Submissions Report

Russell Vale Colliery Commencement of Long Wall 6

Client: Wollongong Coal Limited

04-Jul-2014

Figure 3 Hydrograph monitoring results for CCUS4 and CRUS1

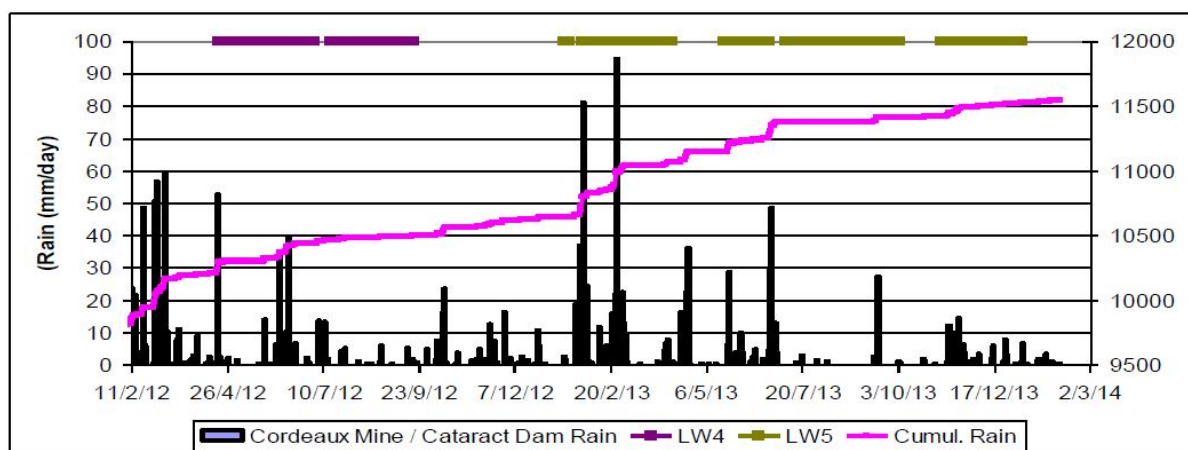
Issues were raised regarding the availability and use of more recent monitoring and baseline data in order to assess impacts to upland swamps as a result of subsidence. In particular, focus on water level response following periods of rainfall.

Updated reports produced by GeoTerra (2014a; 2014b) show the water levels with respect to mining of LW4 and LW5. This includes updated data following completion of LW5. The updated Biosis assessment (2014) used updated data to revise the upland swamp impact assessment, and show swamp hydrographs for CCUS4 and CRUS1 which would be undermined by LW6 (refer to **Figure 3**). The following is drawn from the hydrographs:

Groundwater data from piezometers located in upland swamps indicate varying water levels. The monitored locations within swamps CCUS4 show sustained groundwater levels for prolonged periods following rainfall. This corresponds with the vegetation communities within these upland swamps, with CCUS4 supporting areas of MU43 Tea-tree Thicket and MU44c Cyperoid Heath. Both vegetation communities rely on permanent to intermittent waterlogging have been observed to be in good condition during recent surveys.
